QUAD-1-79-234

Rev. 3

LICENSING REPORT  
DRESDEN NUCLEAR POWER PLANT  
UNITS 2 AND 3  
SPENT FUEL RACK MODIFICATION

REVISION SHEET

FIGURE 3.2-1. STAINLESS STEEL TUBE WITH BORAL CORE FOR DRESDEN FUEL STORAGE

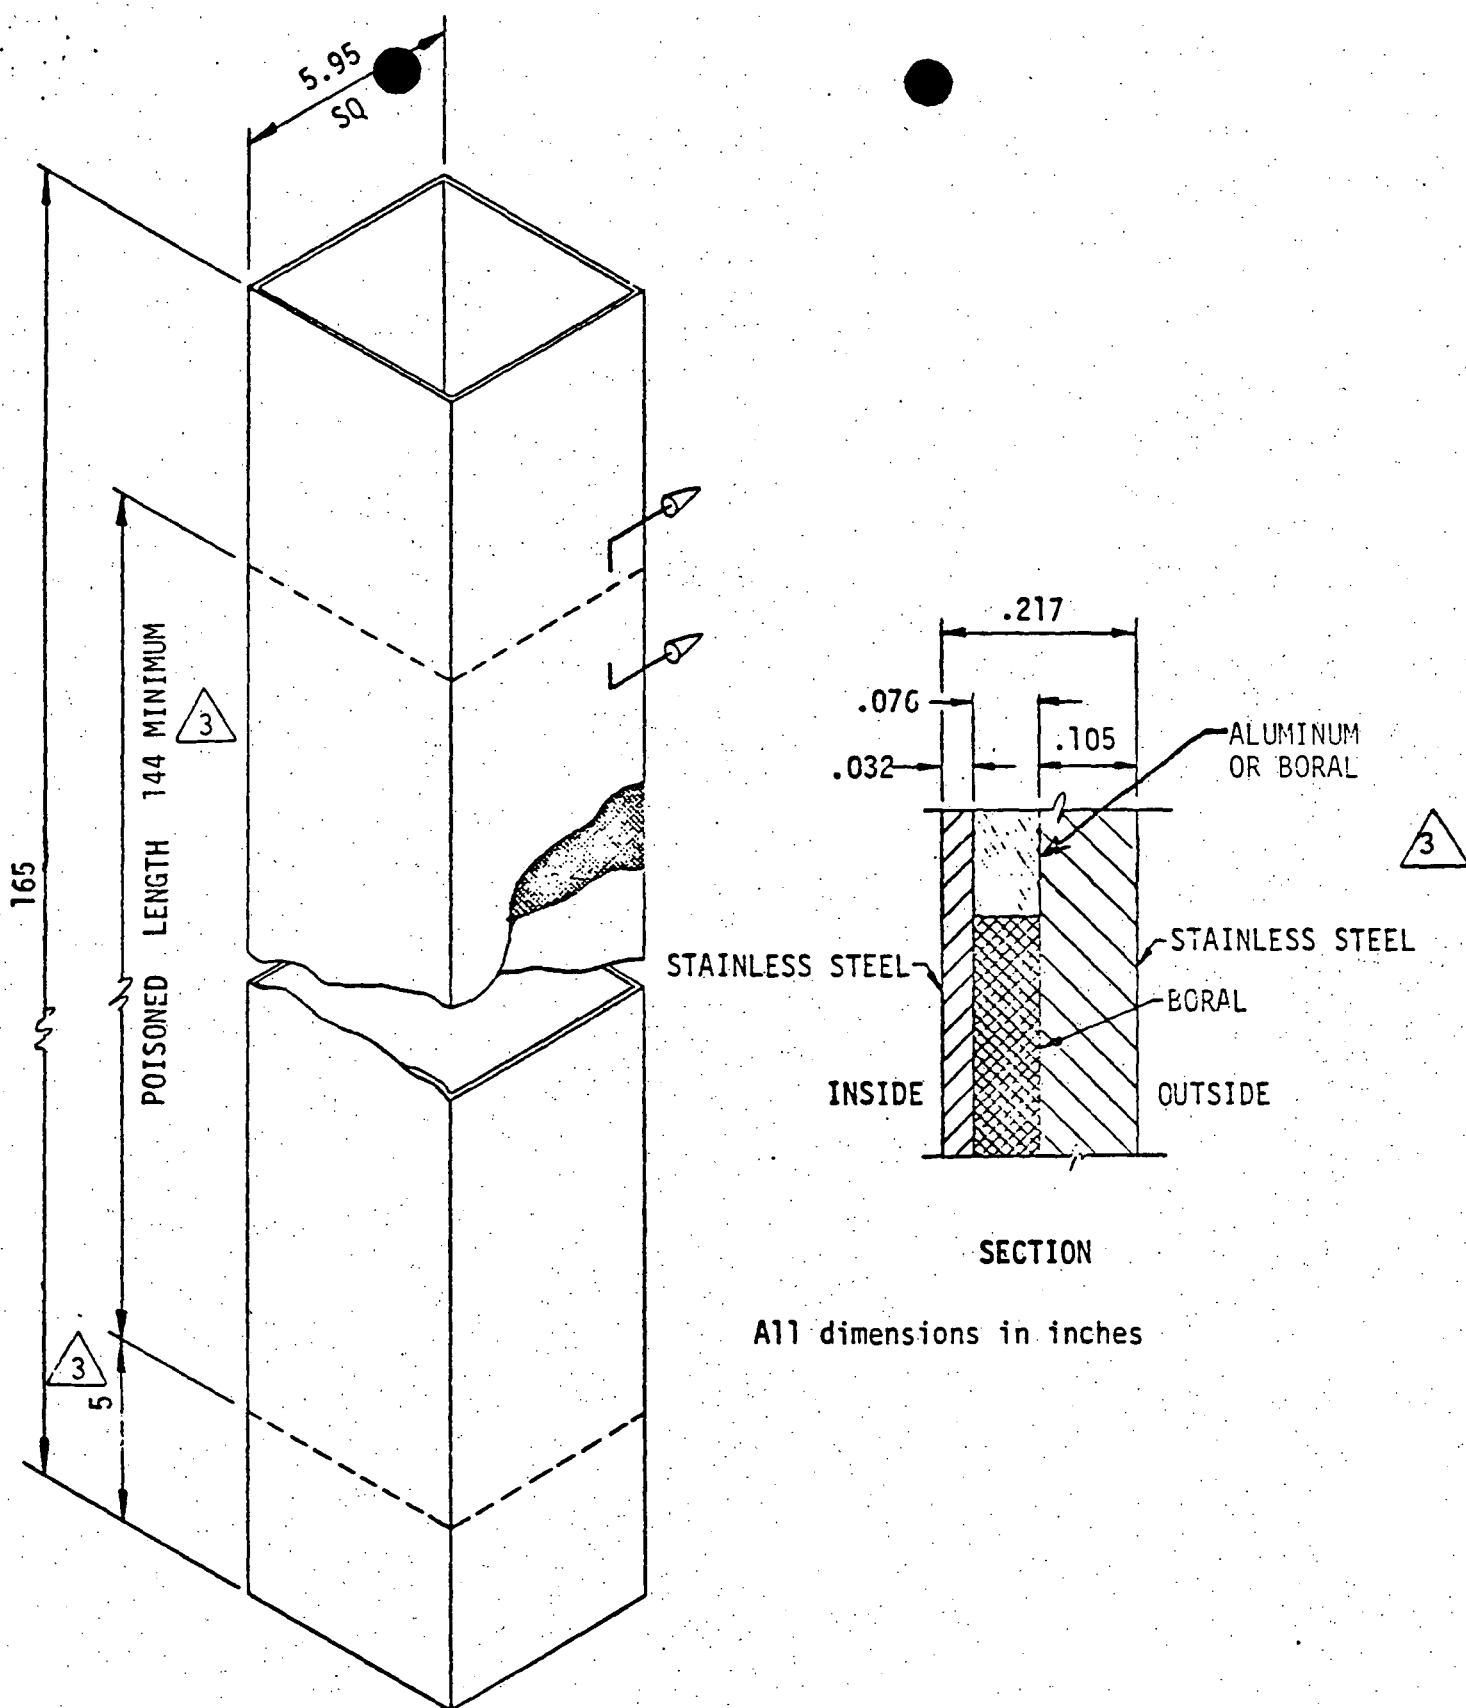
5.	Section 3.2 - Revised number of racks.	3-6
6.	Figure 3.2-1 - Revision of poisoned length from 144 inches to 144 inches minimum and the dimension indicating the location of poison from the bottom of the tube.	3-7

FIGURE 3.2-2. 9 X 13 SPENT FUEL RACK  
DRESDEN UNITS 2 AND 3

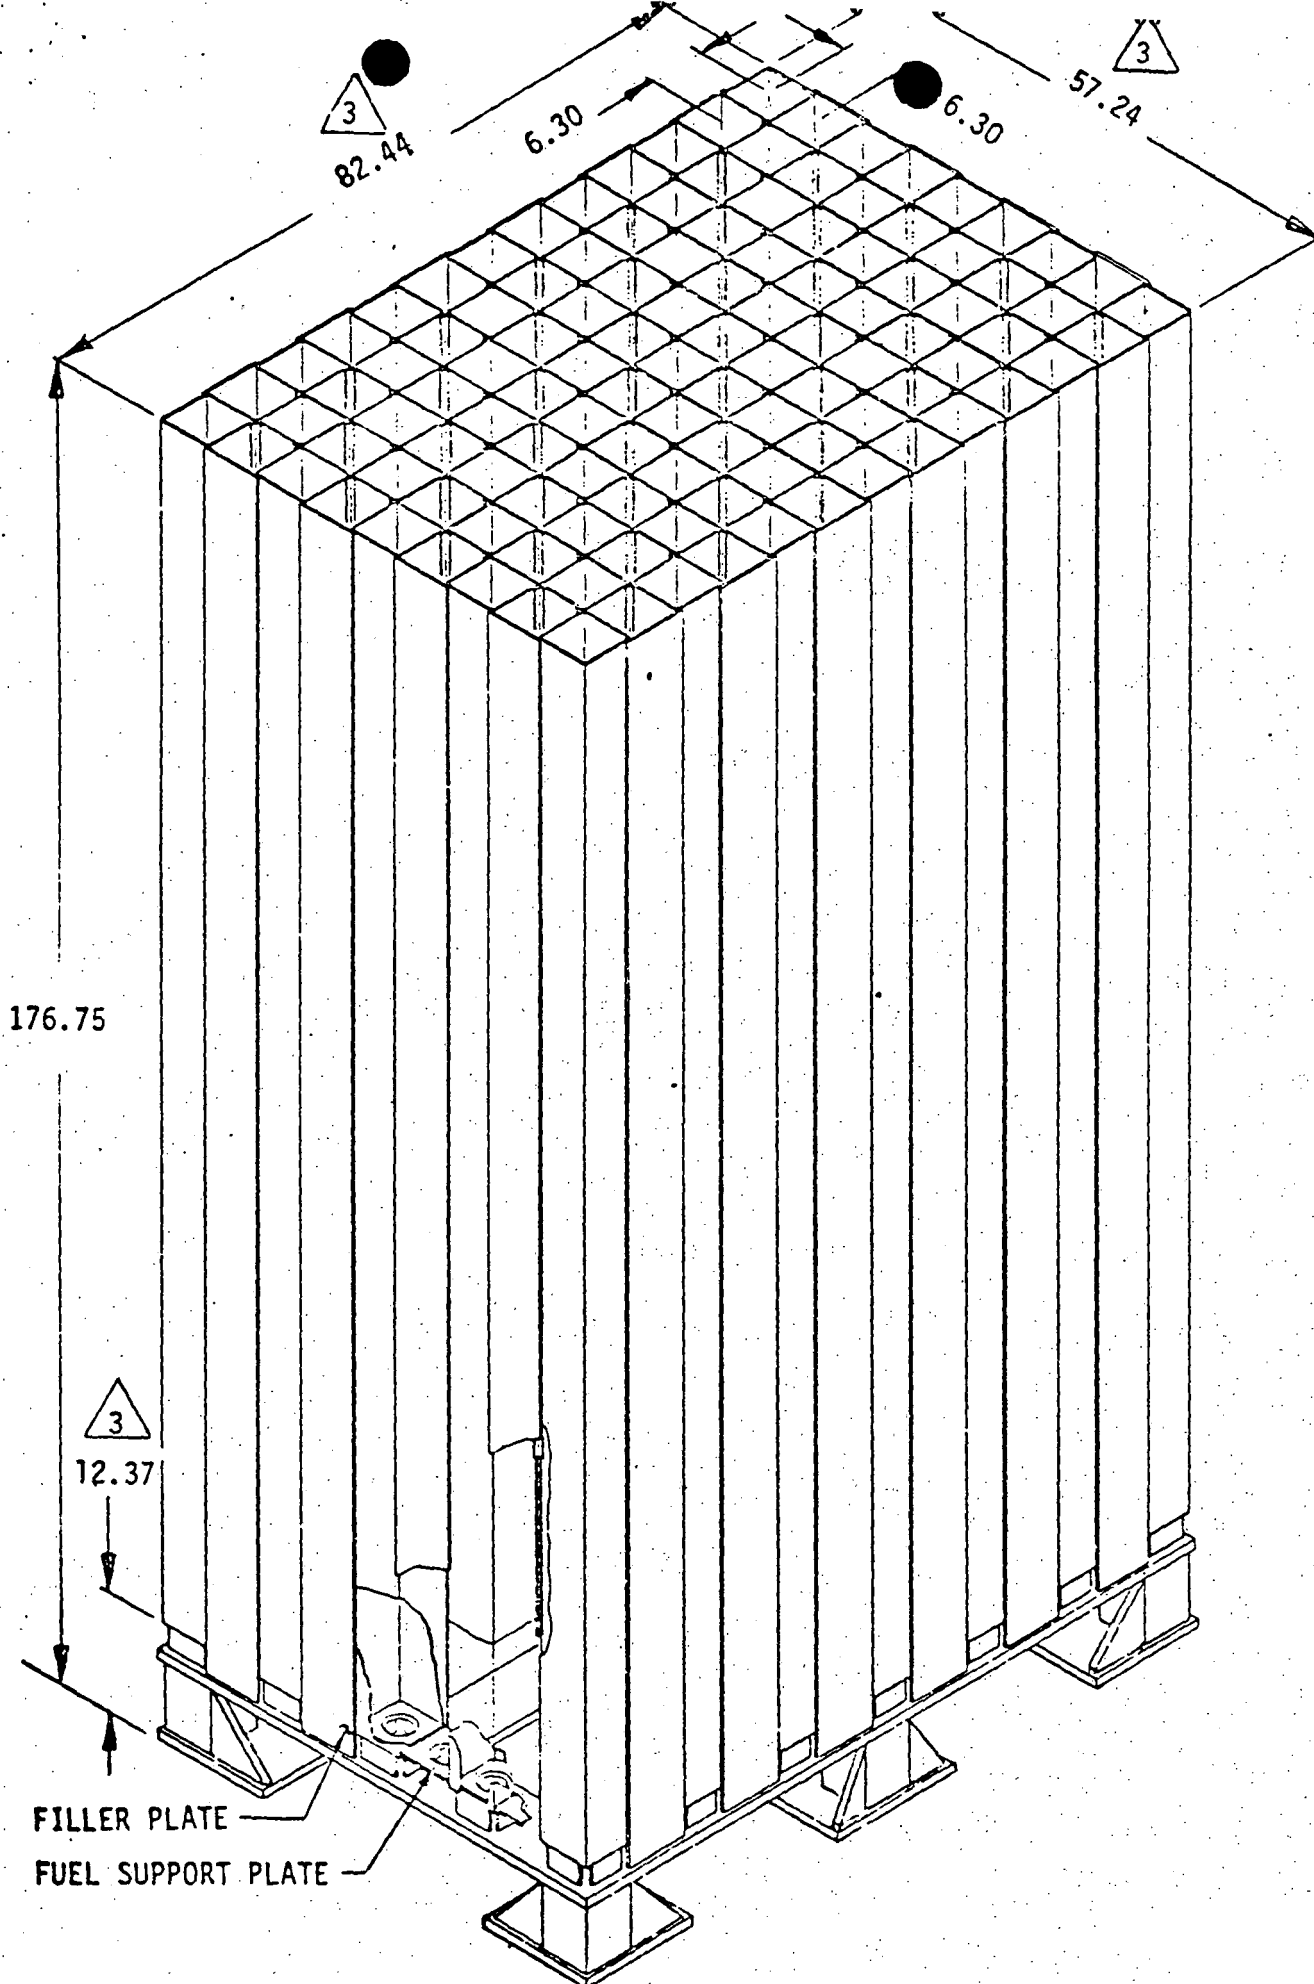
7.	Figure 3.2-2 - Revised overall width of fuel rack and revised elevation of fuel support plate.	3-8
8.	Table 3.3-1 - Revised $\Delta k_3$ and $k_{eff}$ .	3-10

FIGURE 3.3-6. RACKS IN CONTACT WITH EACH OTHER

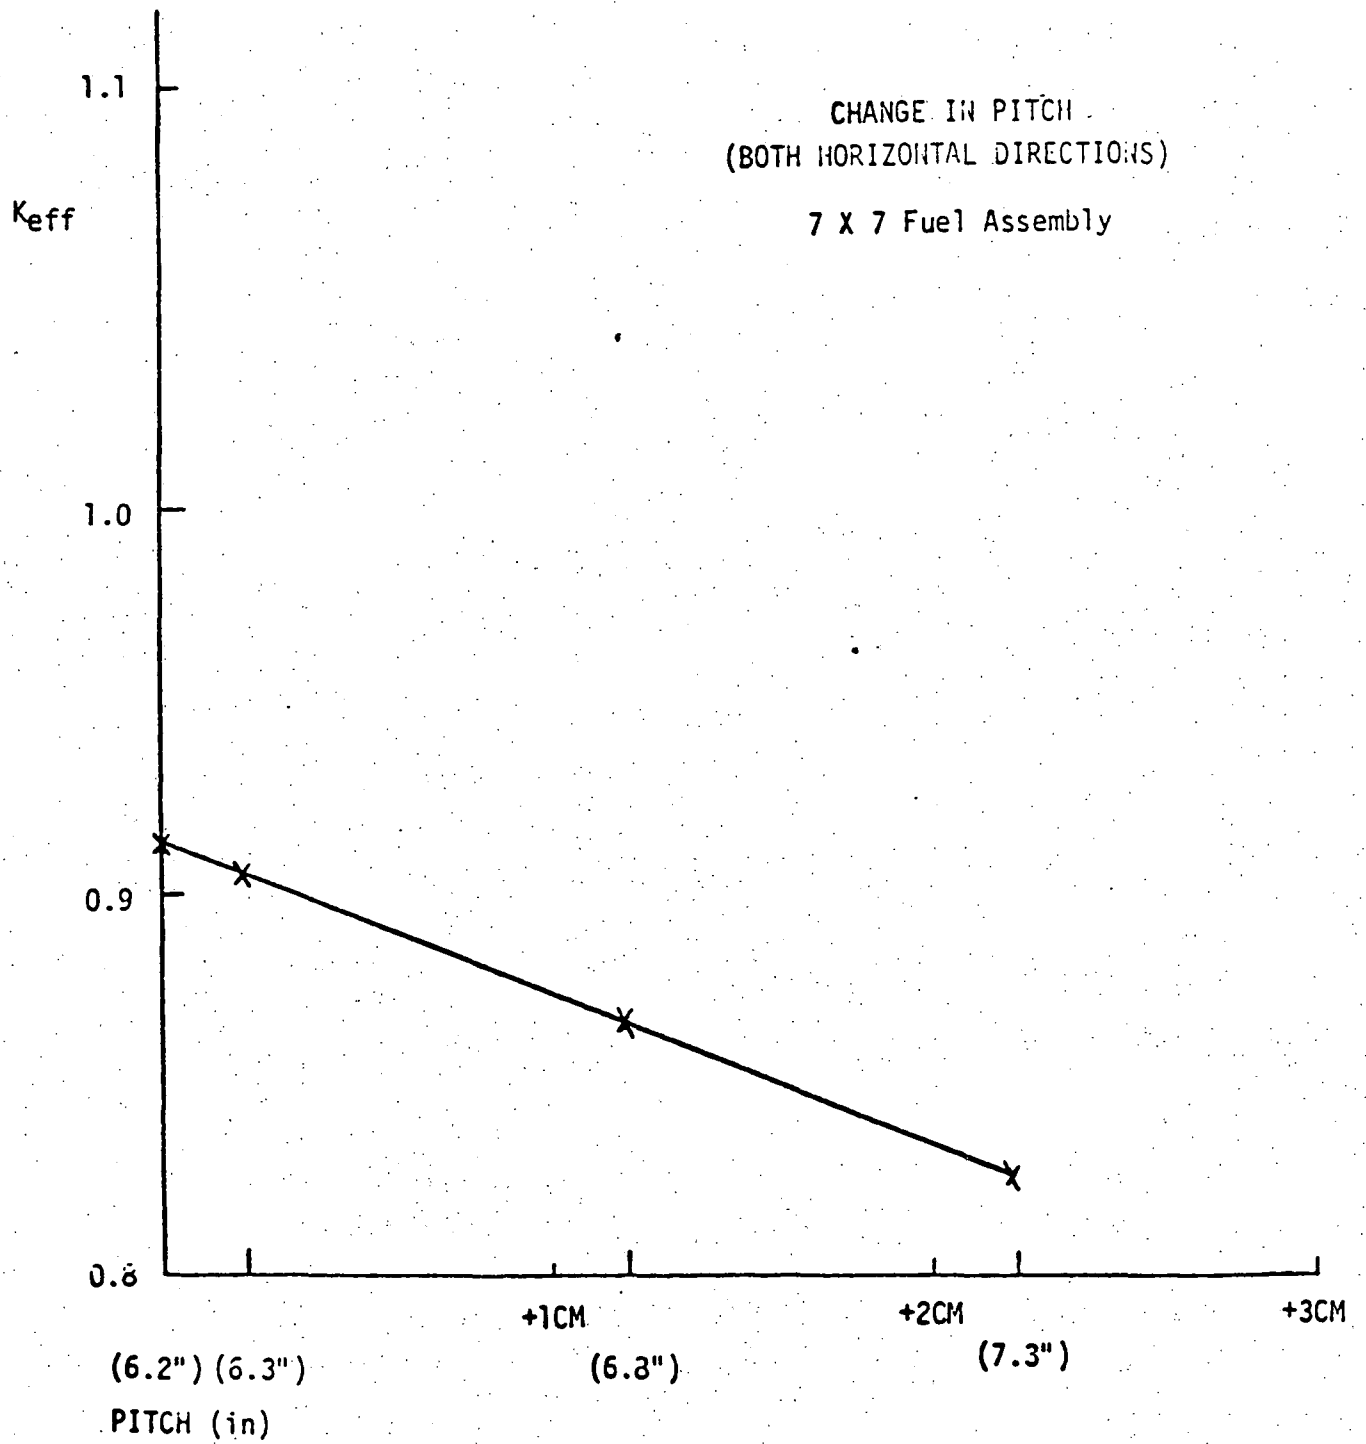
9.	Section 3.3.5 - Revised $k_{eff}$ for condition 5.	3-16
10.	Figure 3.3-6 - Revised figure to reflect the correct geometry of the fuel racks.	3-26
11.	Figure 3.3-9 - Revised figure to include $k_{eff}$ at a pitch of 6.2 inches.	3-29

FIGURE 3.6-9: DRESDEN UNITS NO. 2 & 3  
SPENT FUEL POOL MODEL  
FOR NATURAL CIRCULATION

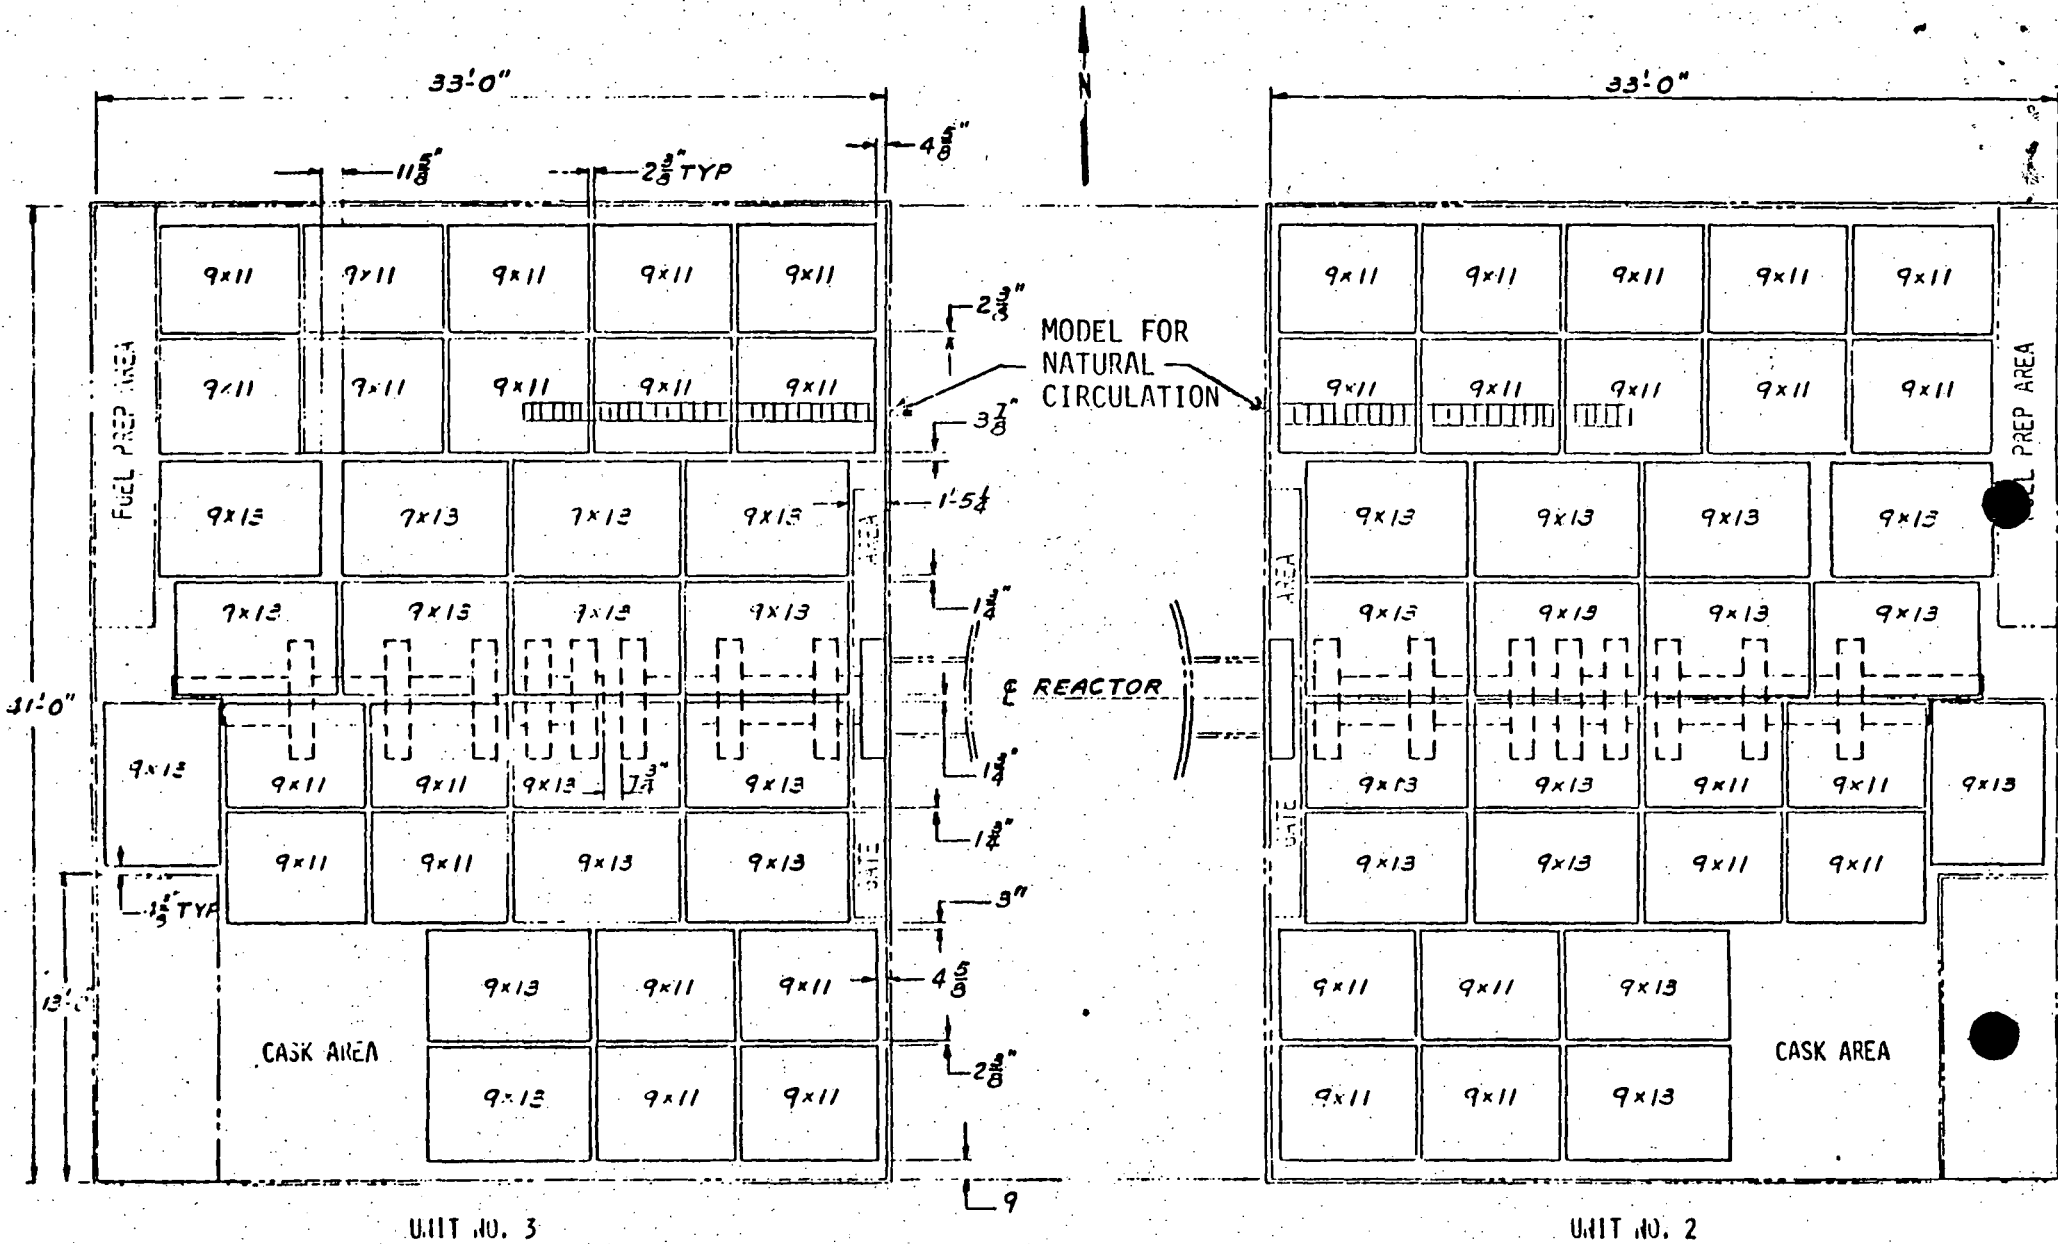
12.	Figure 3.6-8 - Number of flow channels changed from 30 to 28.	3-64
13.	Figure 3.6-9 - Revised fuel storage pool arrangement.	3-65
